**CITY OF BLOOMINGTON
PLAN COMMISSION**

October 2 @ 5:30 p.m.

**BLOOMINGTON PLAN COMMISSION
STAFF REPORT
Location: 318 E. 3rd Street**

**BLOOMINGTON PLAN COMMISSION
STAFF REPORT
Location: 335, 325, 337 S. Walnut St.**

ASITEPLAN

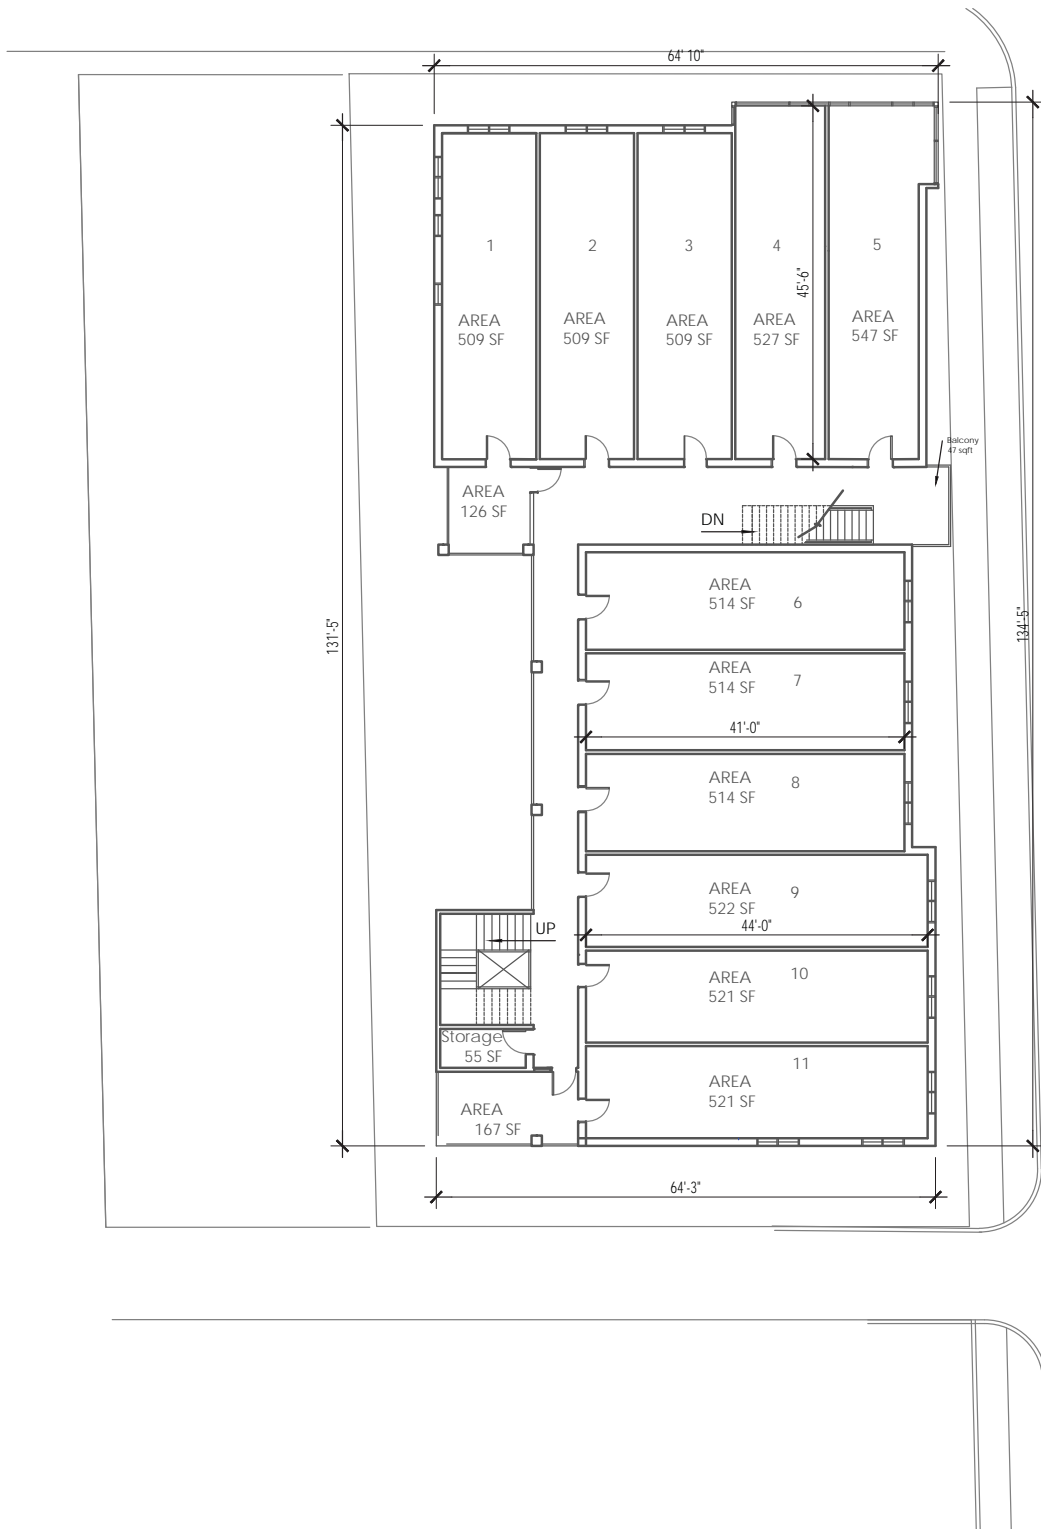
Streetscape: Street trees and pedestrian-scaled lighting are required along 3rd Street and Grant Street. Street trees and street lights are required and must be approved by the Board of Public Works. With the proposed new sidewalk along 3rd Street and proposed work within the right-of-way, the curb along 3rd Street may need to be altered with this project in response to possible changes to 3rd Street and has been included as a condition of approval #3. This will be addressed with the grading permit.

Impervious Surface Coverage: The Downtown Edges Overlay allows for 70% impervious surface coverage and this has been met with the submitted site plan. Portions of the parking area utilize permeable pavers to help achieve meeting the goals of the Green Development Incentives.

- 3.) The Petitioner should develop a pervious paver maintenance plan for all future employees to follow to ensure the pavers continue to function properly

Response: A maintenance plan must be submitted prior to issuance of a grading permit.

EXTERIOR ELEVATIONS - DESIGN CONCEPT

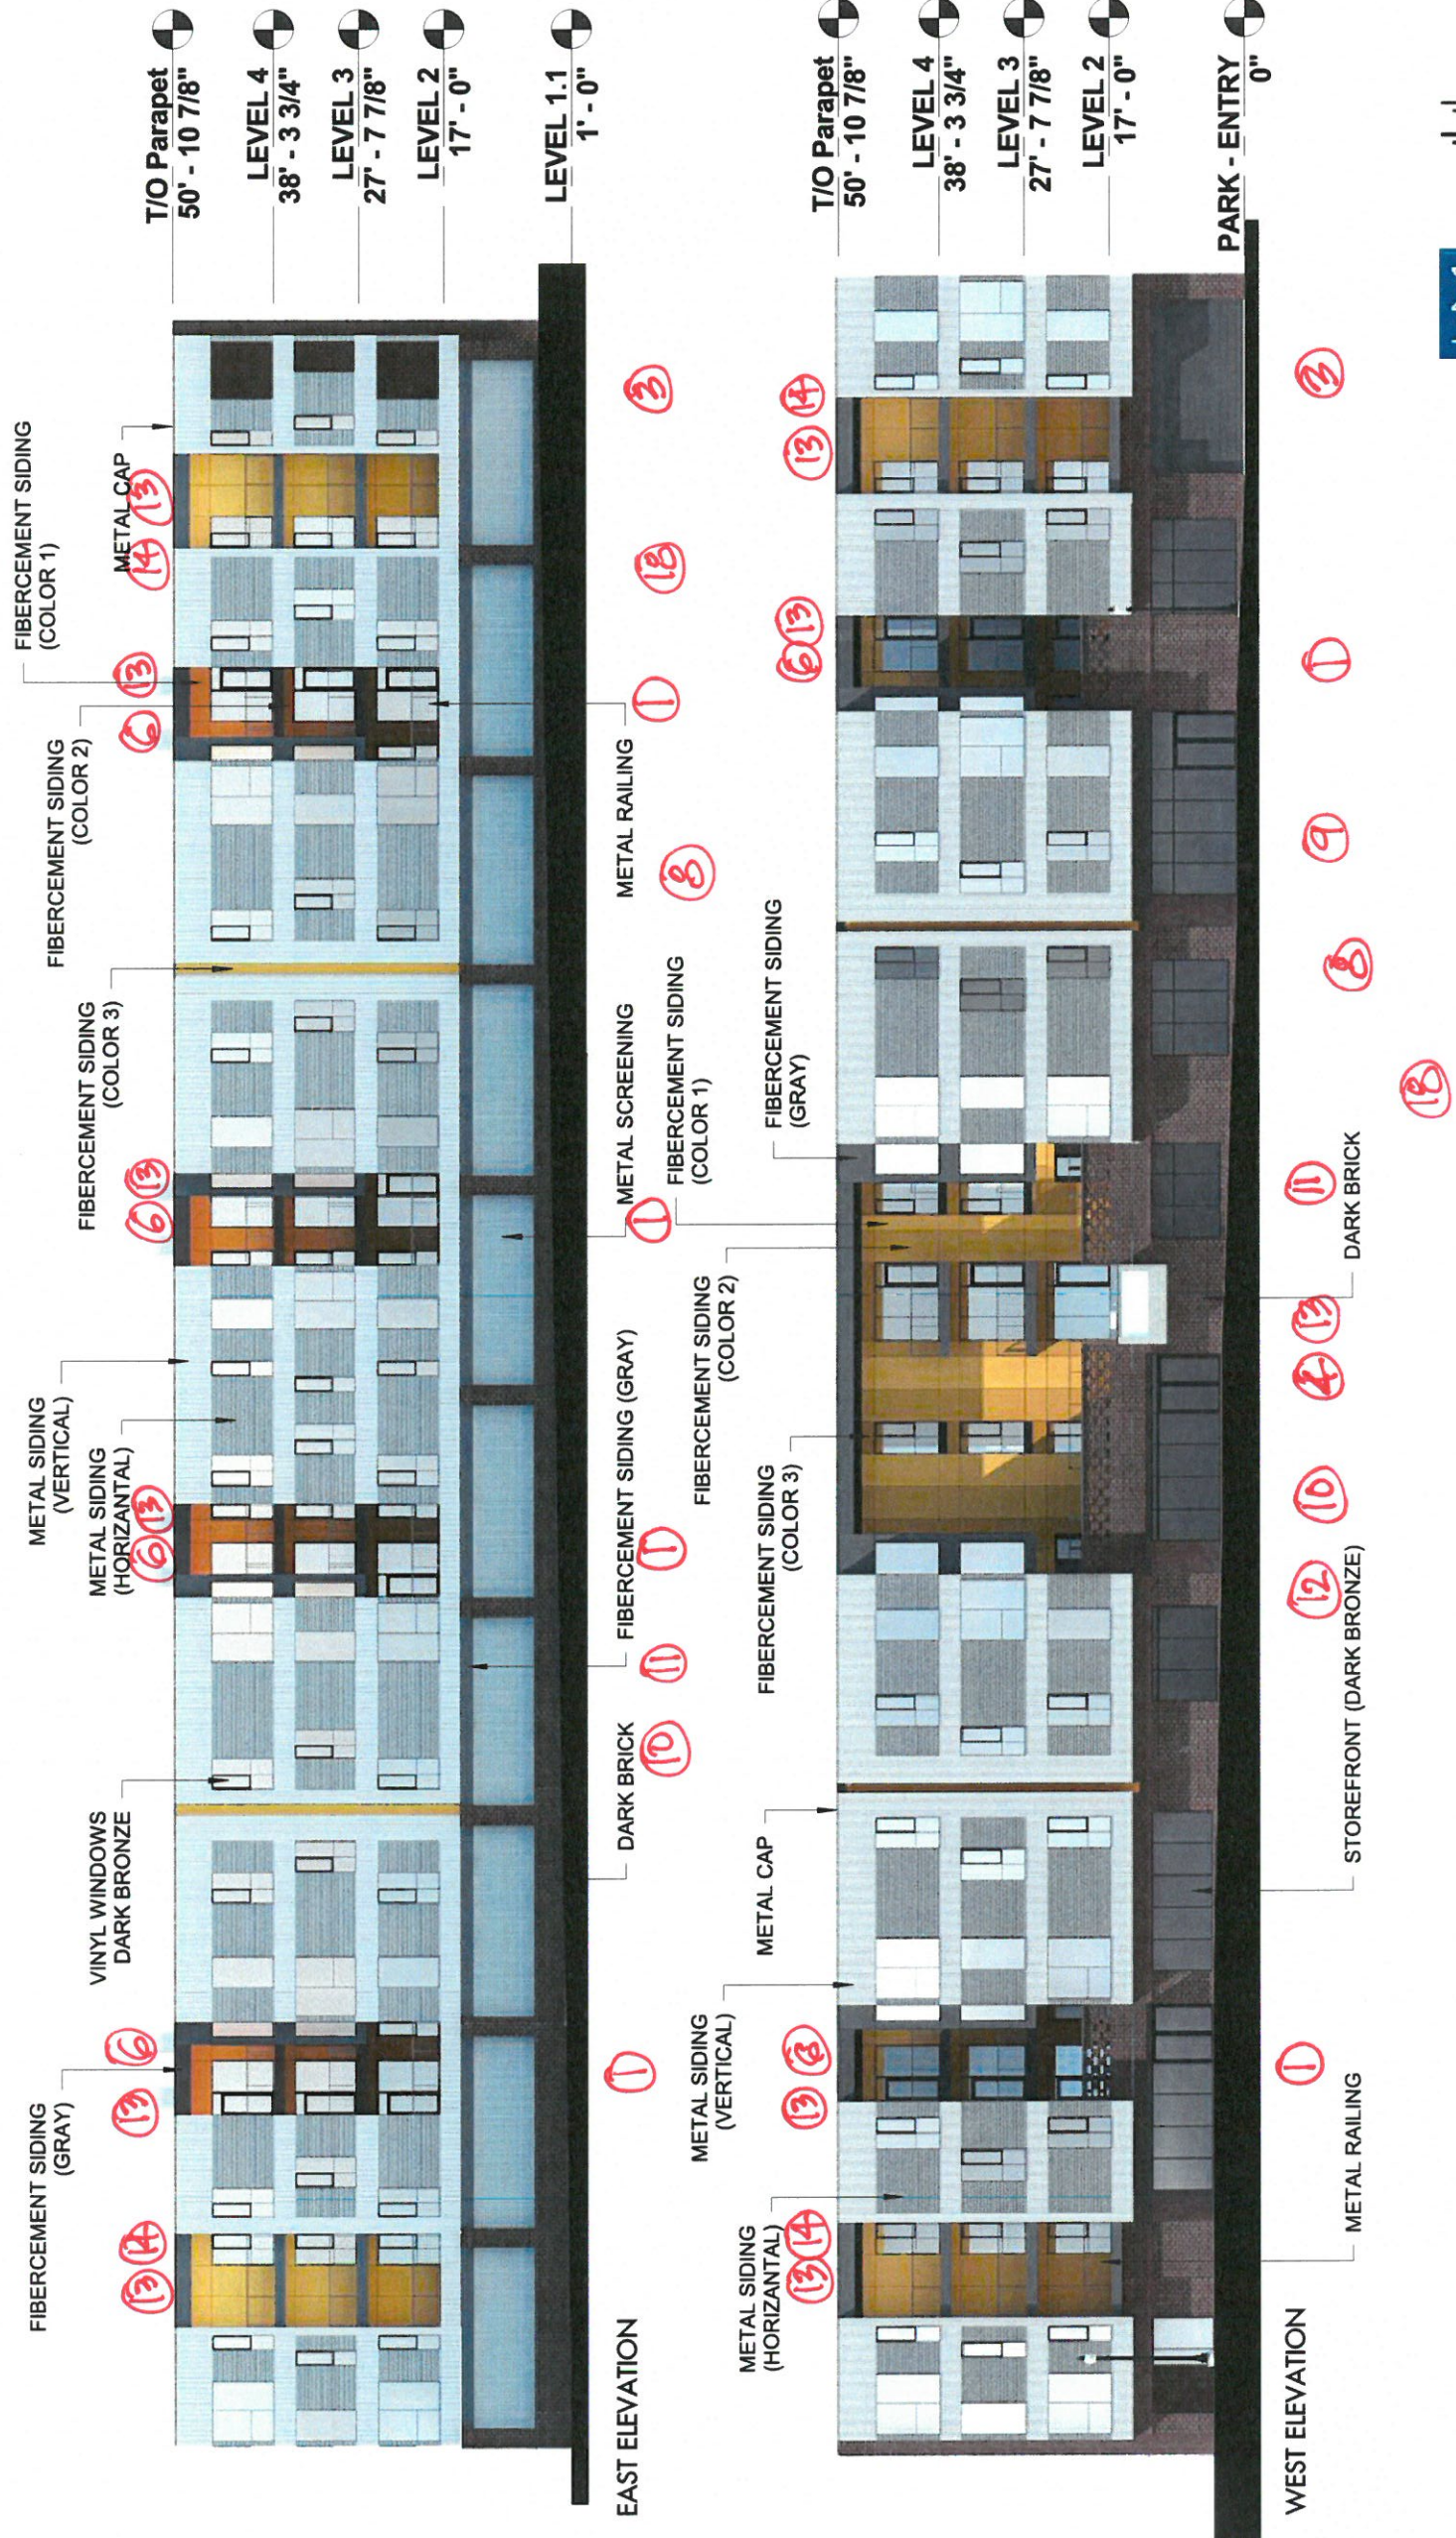
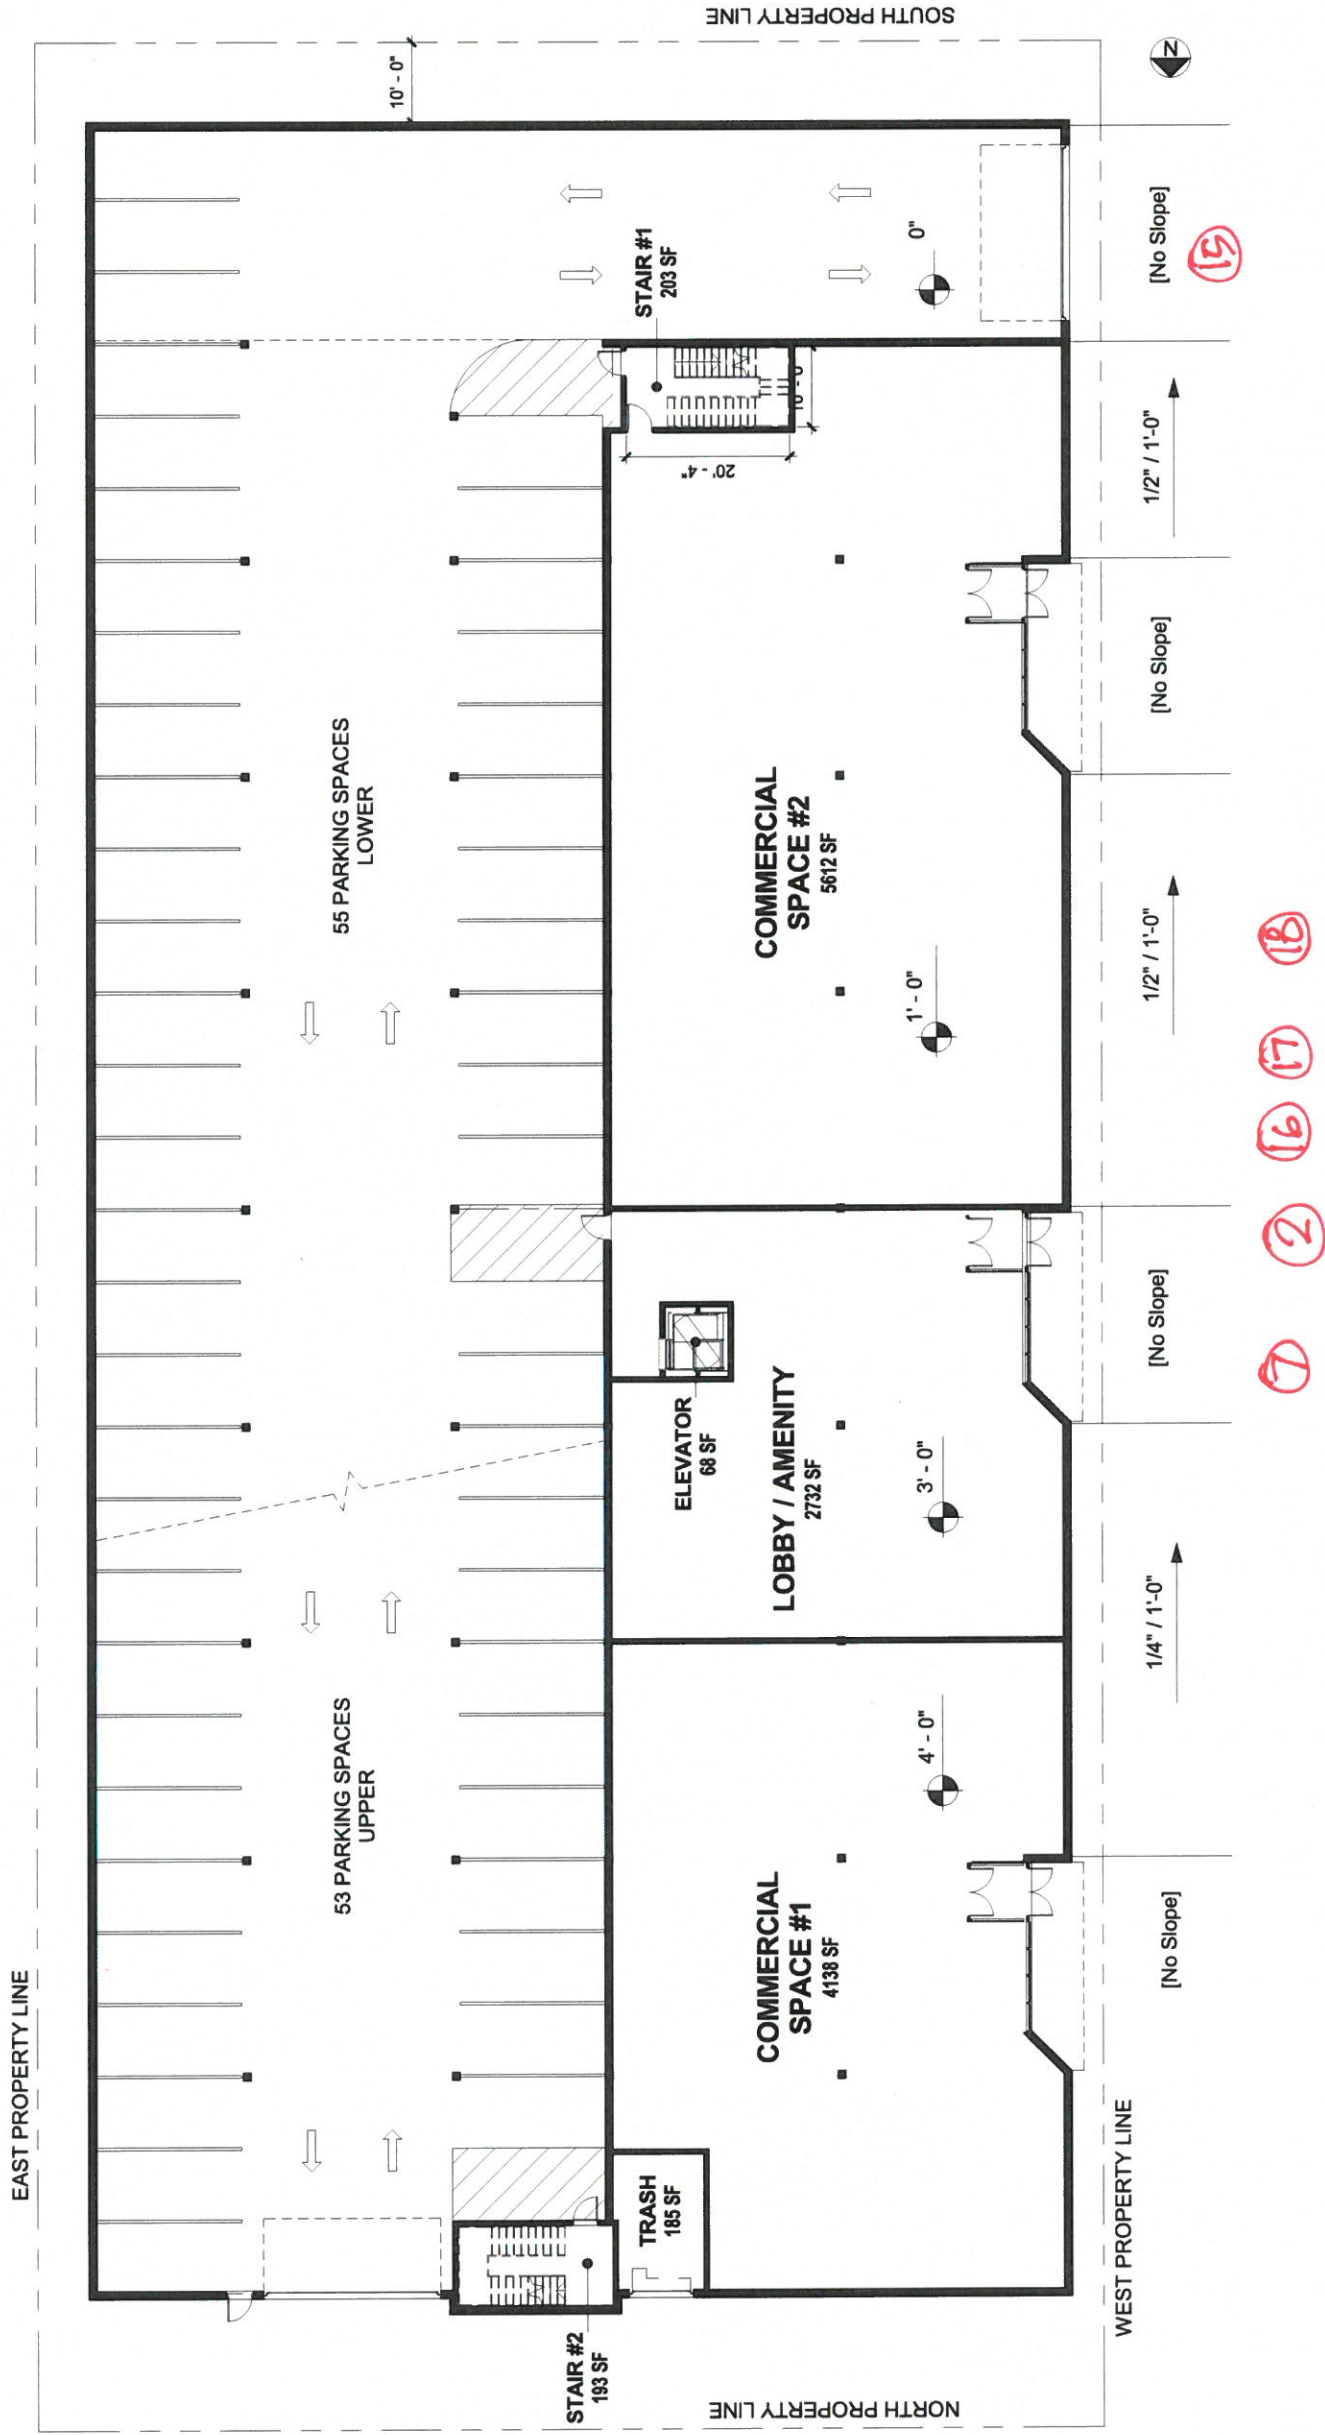
11. A significant portion of the upper three stories, the residential levels, appears to be clad primarily in formed metal panels. The window units appear to be generally flush with the metal panel skin, offering only minimal relief of the visual “flatness” of these blocks. Consideration should be given to further differentiating the surface of the visual “framing” of the floor levels from the infill panels, possibly by offsetting them from each other which would provide some additional shadow lines.

12. Additional detailing including limestone trim or brick detailing is needed at the podium level. It would provide a local material connection and add some scale and interest. The application of the brick masonry screen wall at the perimeter of the Second-Floor courtyard spaces is an example of this, but likely too high for pedestrians to appreciate or even notice. Some modulation of the podium masonry plane would be beneficial at the residential entrance or commercial entrances.
